TO: Mayor Andre Dickens, City of Atlanta
ATTN TO: Monique Forte, Planner III, City of Atlanta
FROM: Mike Alexander, COO, Atlanta Regional Commission
RE: Development of Regional Impact (DRI) Review Finding

Name of Proposal: Cypress Grove DRI 4023

Description: A DRI review of a proposal to construct a residential development with 755 multi-family units on a 20-acre partially wooded site off of Cato Street NW and Hollywood Road in the City of Atlanta.

DRI # 4023 SITE PLAN
CYPRESS GROVE LAND FUND
LAND LOTS 246 & 248 - 17th DISTRICT
CITY OF ATLANTA
FULTON COUNTY, GEORGIA

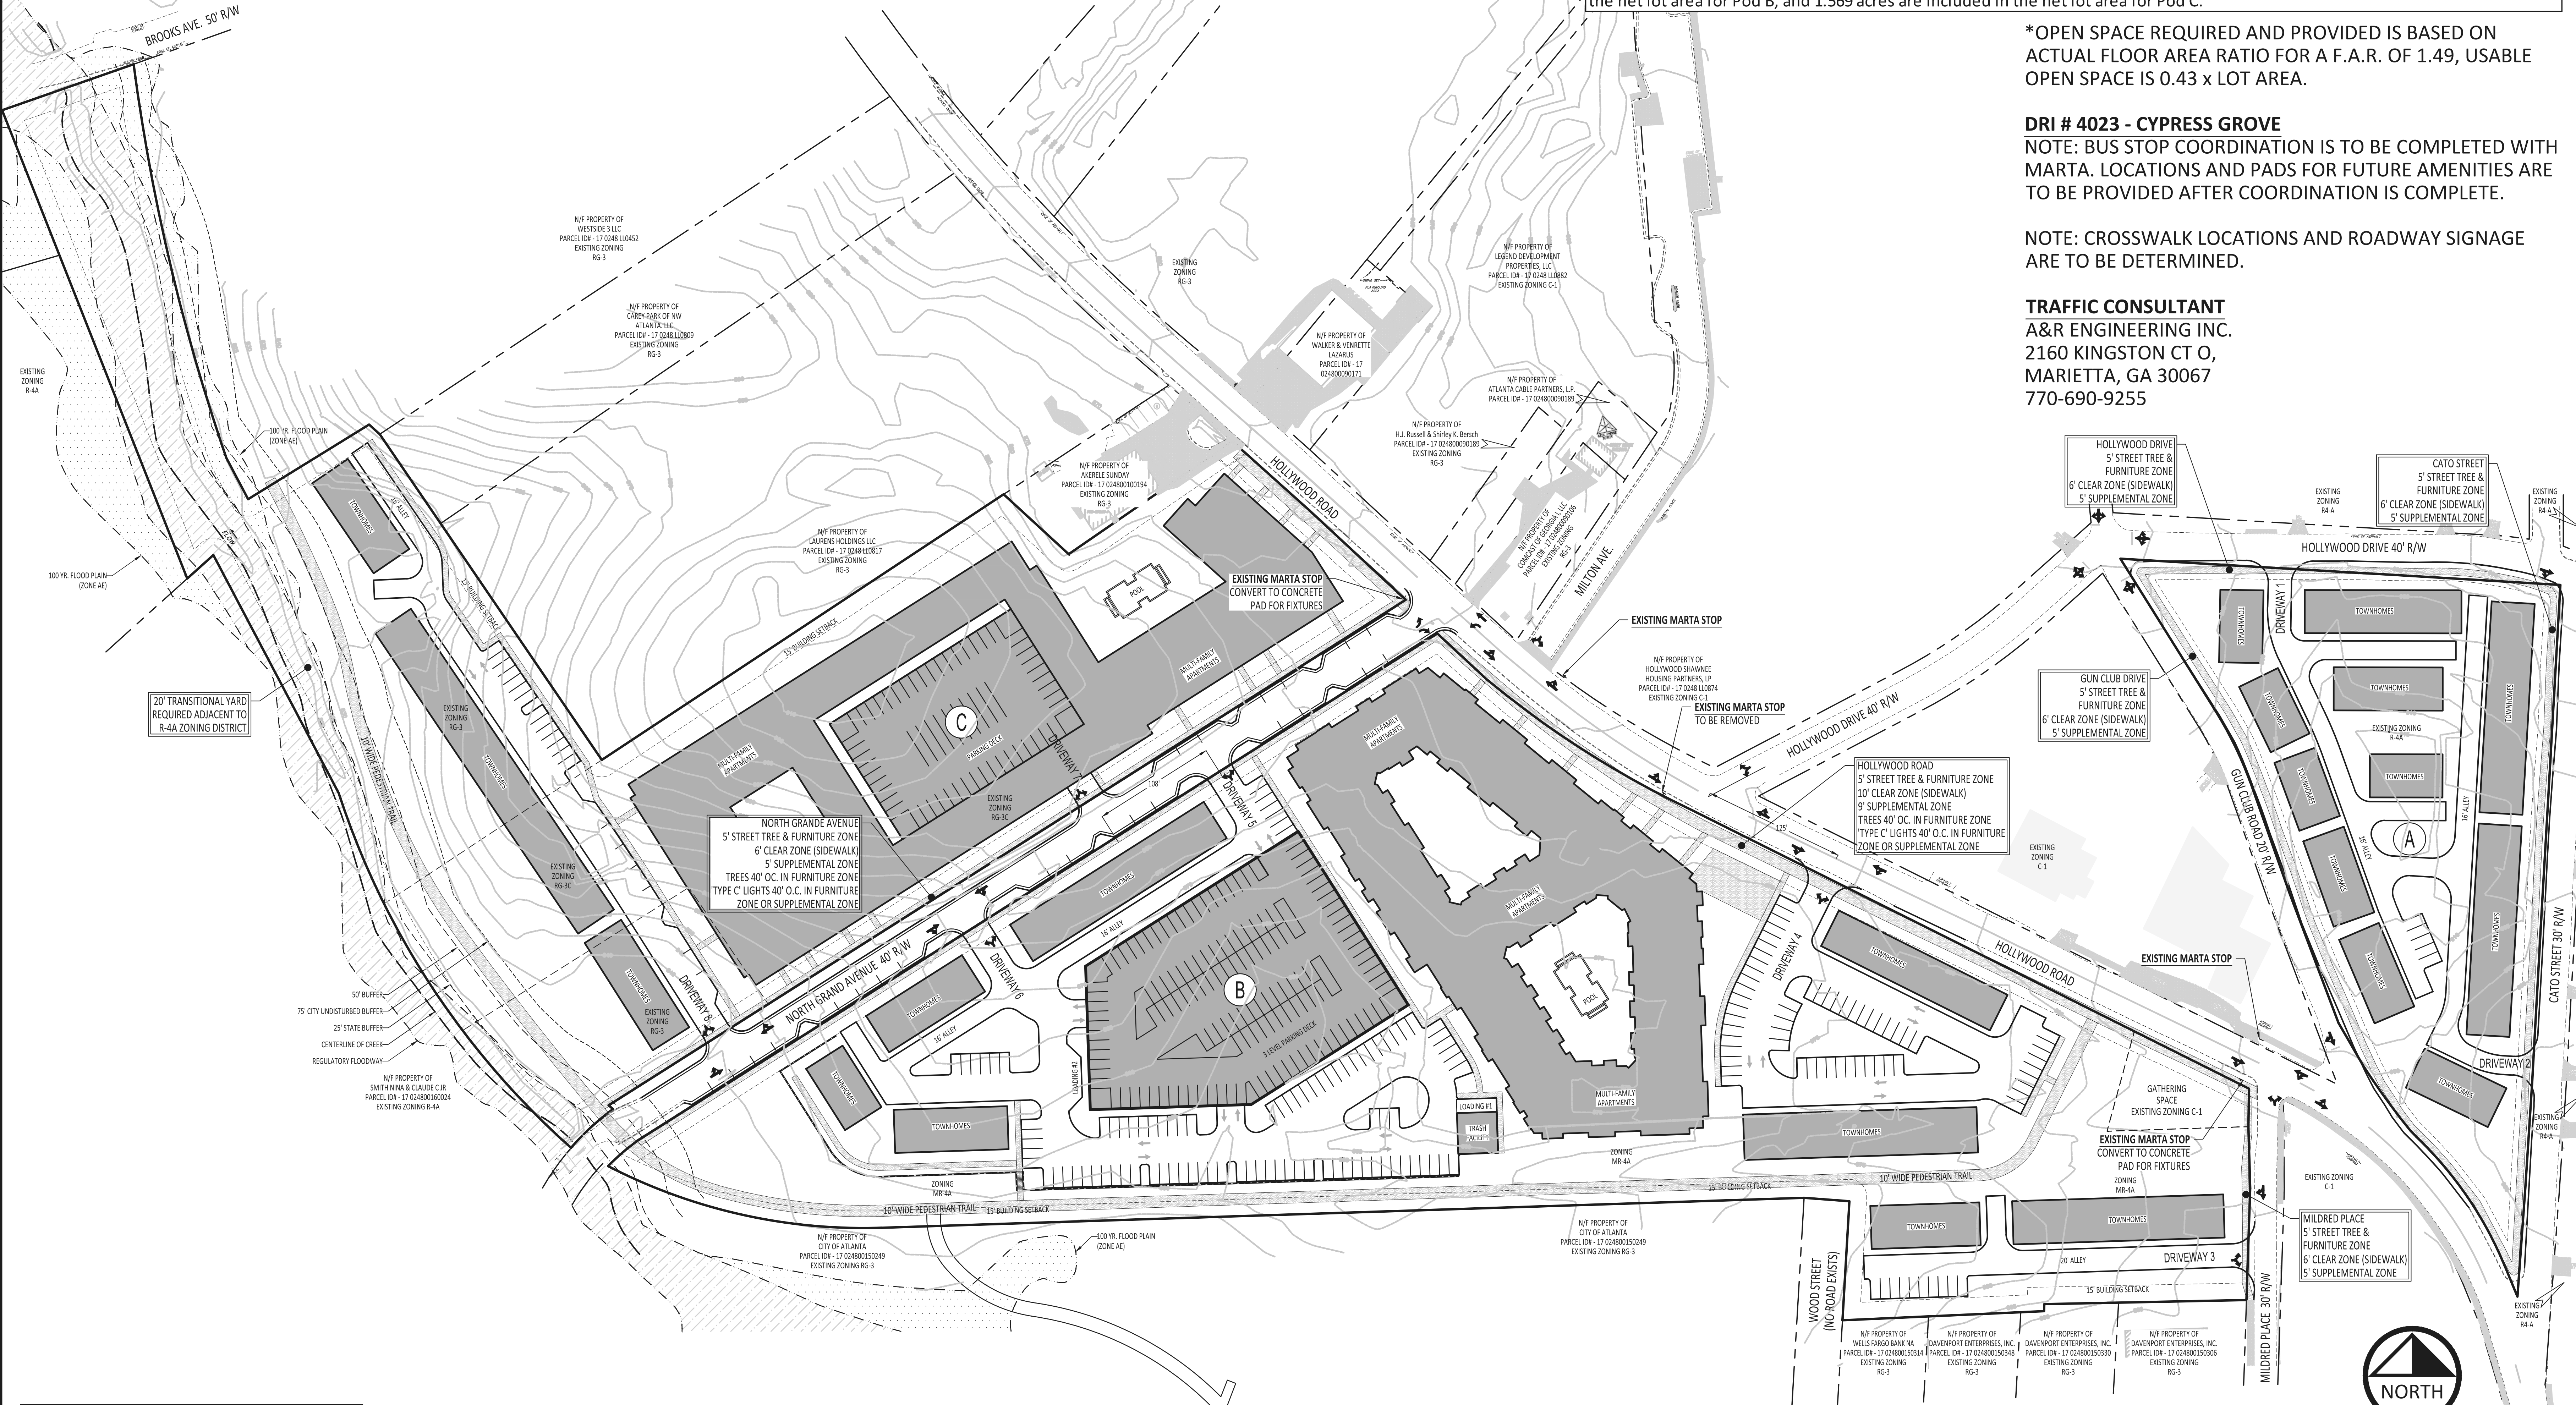
REVIEWER				DESIGNER RESPONSE		
Comment #	Drawing/ Document Page Number	Comment	Initials	Code No*	*Response By/Designer's Notes	**Verified By
1.	Site Plan	The number of driveways for this site is a bit excessive. Consider consolidating some of the proposed driveways. New driveways should be minimized and old driveways should be eliminated or consolidated

2.	Programmed Projects	Add Moving Atlanta Forward sidewalk repairs on Hollywood Road to programmed projects				
3.	Site Plan	Desired Streetscape: Per Streets Atlanta Design Guide (section 4-15), this corridor would be considered a Suburban Collector, which should have 6' sidewalks/clear zone with 5' planting/furniture zone

4.	Site Plan	Crosswalks at N. Grand Ave: Consider an all-way stop to minimize potential conflicts with left turn movements and people crossing.				
5.	Site Plan	Consider aligning the intersections at Milton Ave and N. Grand, and Hollywood Dr with the proposed driveway in site plan to support the creation of a safe, sustainable, and interconnected street network.

6.	Site Plan	Use Streets Atlanta Design Guide methodology, and FHWA STEP guide for the ped crossings & mid-block crossings				
7.	Trip Assignment Methodology	Change northern segment of Hollywood to 25%, reduce Wood St to 10% and add 5% to N. Grand

8.	Site Plan	A traffic study would be required if the project reached the Development of Regional Impact (DRI) threshold. The DRI should also include a Traffic signal warrant study – Hollywood Rd & Gun Club.	ATLDOT

9.	Site Plan	Include on the Roadway design / additional traffic study considerations – report multi-modal operations (delay/travel time) and safety performance measures (crashes, conflict points, CMFs) Sight distance and speed considerations. Our latest traffic calming policy is in development, so we are relying mostly on the national practices until that is	ATLDOT

10.	Site Plan	Please display the MARTA stop, to connect with the developer-proposed sidewalk further south, along their site frontage for any further information please contact Mr. John Saxton at jmsaxton@AtlantaGa.Gov , Will be necessary to provide adequate connections for community transportation.	ATLDOT

11.	Site Plan	Please provide an adequate transition to the existing sidewalk and repair any section that needs to comply with Sec. 138-14. - Maintenance of sidewalk area.	ATLDOT

12.	Site Plan	Will be required to align your driveway apron with Hollywood Dr following Sec. 15-08.002. - Streets - Centerlines of proposed intersections shall align with the centerline of existing streets or shall be offset at least 200 feet from the closest intersecting street. Street intersections shall be as nearly at right angles as possible. This was requested by CRC permit and also included a Zoning (Z-23-041,042,043) permit review. The 125 feet is not acceptable. Previous image  DRI image 	ATLDOT

REVIEWER			DESIGNER RESPONSE			
Comment #	Drawing/ Document Page Number	Comment	Initials	Code No*	*Response By/Designer's Notes	**Verified By
13.	Site Plan	Provide, and display in the drawing, the standard detail that applies to your road frontage. 1. driveway apron TR-B_DR005 2. sidewalk uses TR-B_SW004 3. Match with the existing curbing on site (install or reset 6 inches over the street level). 4. Refresh the existing pedestrian crossing and stop bar and stop signs where applicable. For the new driveway aprons please include the stop bar and stop sign. 5. ADA ramp on each intersection with detectable panel 6. ADA General Comment – refer to PROWAG R304.4	ATLDOT

14.	Site Plan	ATLDOT will not allow the installation of any trees near the driveway interception or ADA curb ramp that can block the sight distance. Security in public areas will not be compromised. Provide a sight distance study for the proposed connection to the public road and relocate any obstruction as a result of the report. The other trees shall be limbed up a minimum of 7 feet at the time of installation (IN PERPETUALLY) to keep buffer zones clear at the triangle's sight distance. Check with the Arborist's Department and include the note in the plans.	ATLDOT

15.	Site Plan	STREET LIGHTS GENERAL COMMENTS - This is required for all new developments to provide light in the ROW. Please contact me, if you need further clarification Stephen A. Adesanya: asadesanya@atlantaga.gov 470-542-9656 Office 404-658-7862 (Ext. 15). a. Provide Street lights information including existing and proposed for comments/ review. b. Provide specifications and details of wiring procedures, and checklist. C. Provide and include on the street lights plant the trees. D. Provide 6' OC from the driveway apron and 3' from ADA flare E. 15' OC from tree F. Provide 3' from the back of the curb to the beginning of the base of 4' OC. According to the checklist. G. Adjust the layout & location of the street lights as per the checklist & label all of them (CH, C, C, CH). Layouts must begin with a Cobra head (CH) or Type A light at intersections and driveway aprons. The layout follows CH/A C C ... CH/A unless otherwise noted in City codes.	ATLDOT
